From: [REDACTED]
Sent: 03 July 2024 06:25
To: [REDACTED]
Cc: [REDACTED]
Subject: URGENT Comments on Application DM/23/2493 MSDC

I have had the opportunity to review your consultation response letter dated 26th June 2024 to Hamish Evans of Mid Sussex District Council in relation to a planning application DM/23/2493.

Figure 3.9 Additional area of visibility on the outside of a curved major road

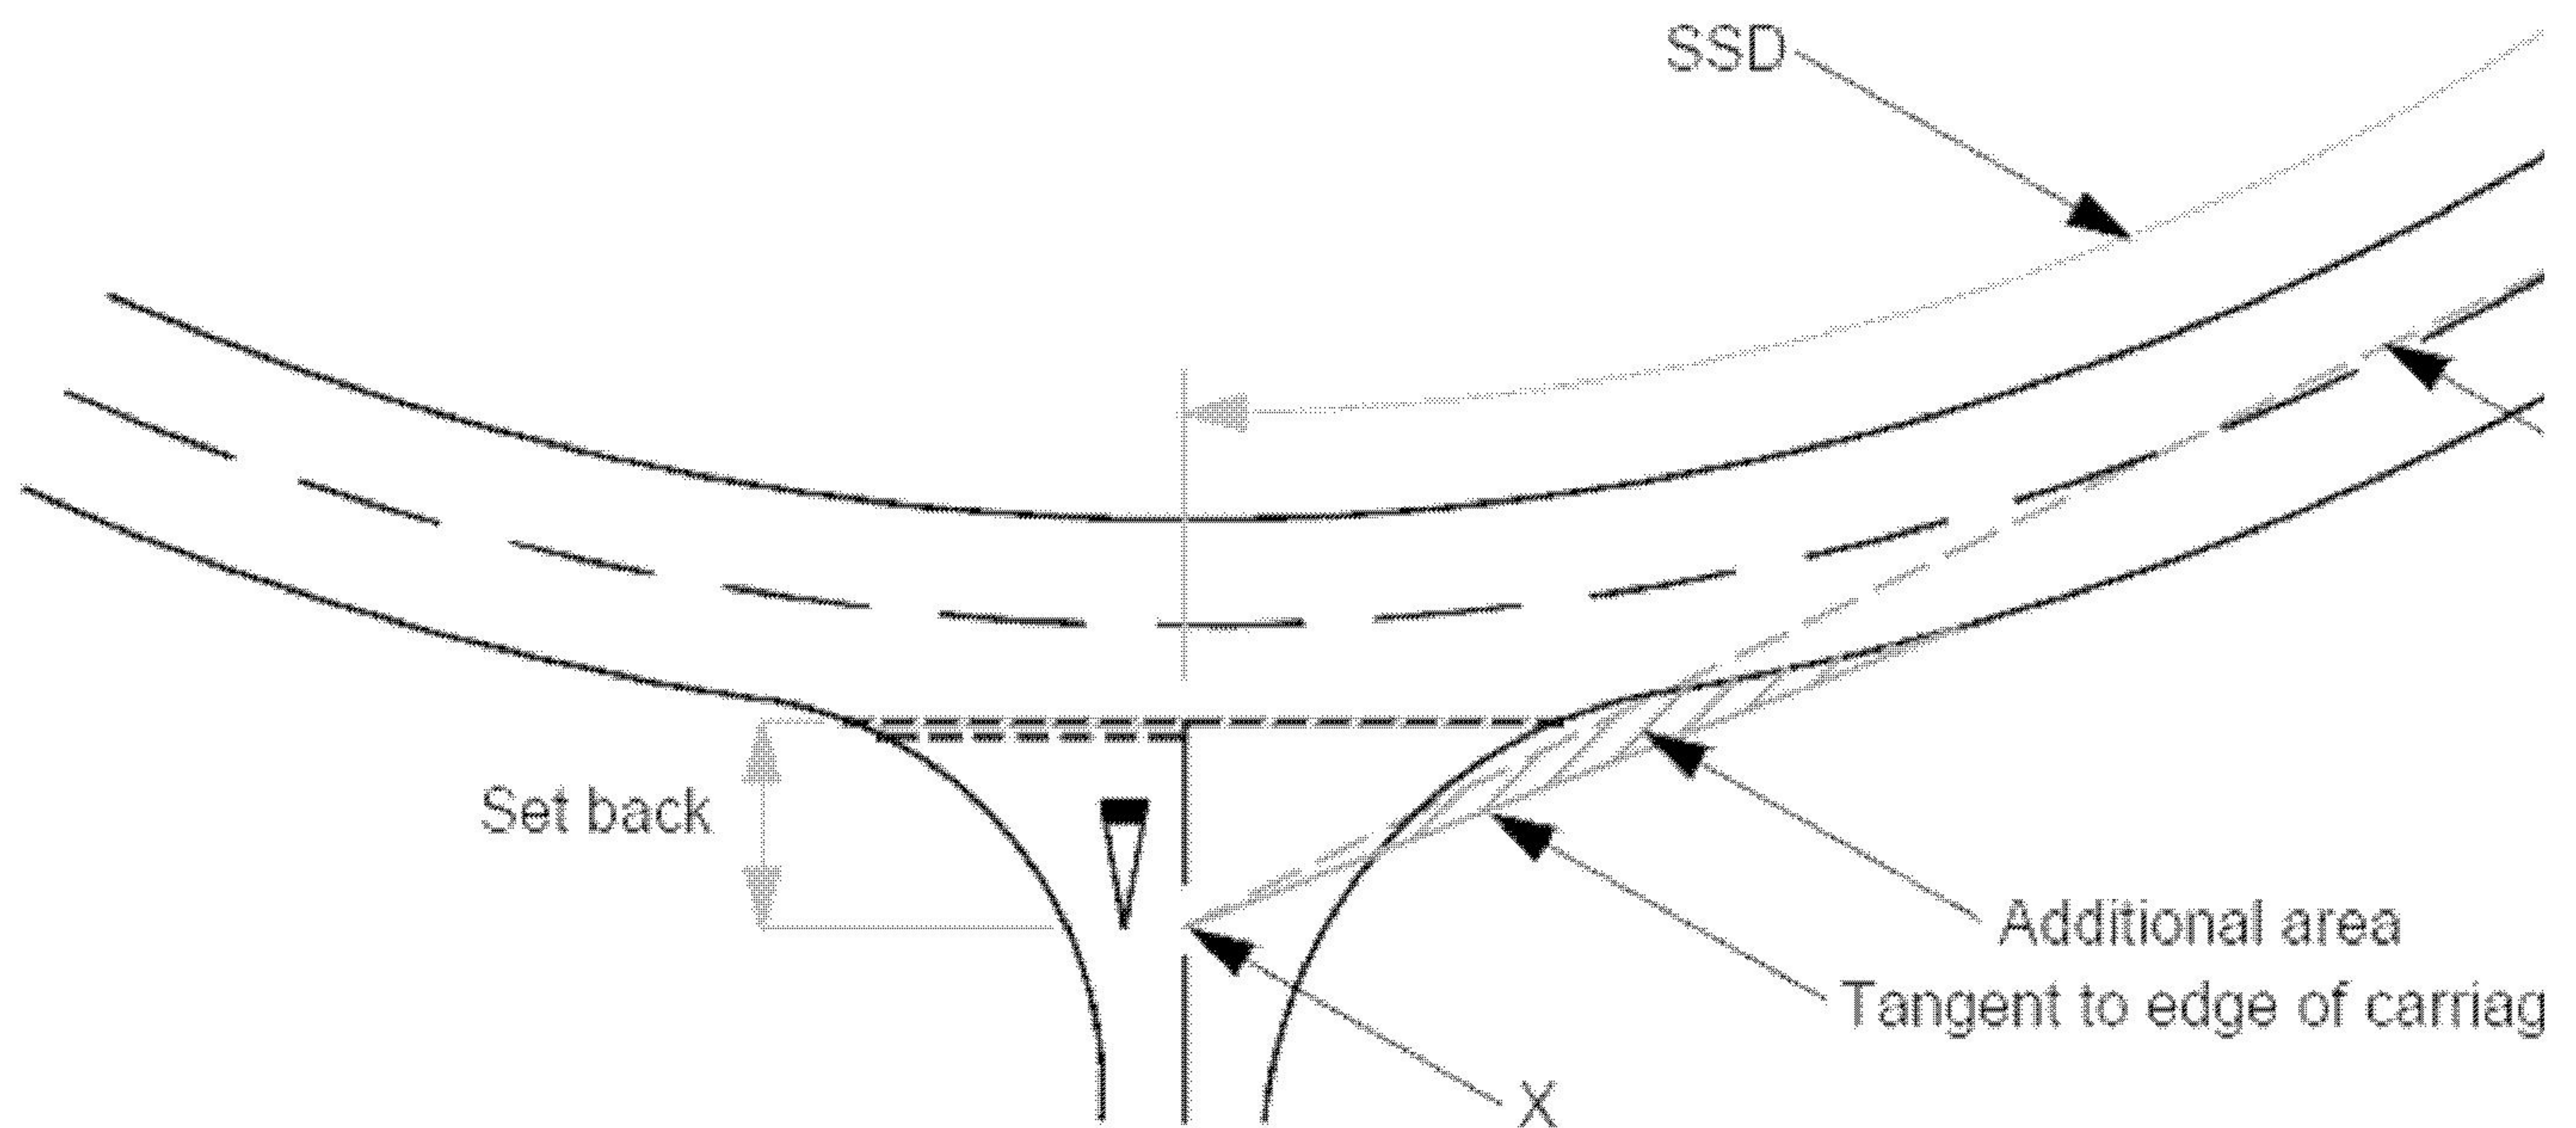
3.9 Where the line between points X and Y falls partially within the major road carriageway, an additional area shall be added to the visibility splay formed by drawing a line from X to a point tangential to the nearer edge of the major road running carriageway, as illustrated in Figure 3.9.

Clearly, in the narrative in item 2. Paul Willis accepts that Yes Engineering did not draw the visibility line to the tangent as required by DMRB CD123 V2.1.0 Section 3.9, and he gave as one of the reasons for not doing so as *'it is extremely difficult to ascertain the exact position of the tangent point due to the lack of defined carriageway'* (strangely no such difficulty arose during the topological survey in surveying the whole road which Yes Engineering claim as best practice). In fact no attempt whatever was made to comply with Section 3.9 as Yes Engineering drew the line halfway across the carriageway at the point where it should have been tangential and claimed that was acceptable as motorcycles don't ride at the edge of the carriageway.

So in summary, Yes Engineering have chosen to ignore a whole section of DMRB standards and claimed that there is flexibility to do this *'when all factors are considered'*. But what are the factors in this case? Why would a sub-optimal solution be acceptable in this case? There is no physical impediment to fully complying with DMRB. The answer is simply that Yes Engineering do not wish to admit that a DMRB compliant solution, therefore the optimal safety solution, requires the use of third party land. The impediment isn't physical, it is legal.
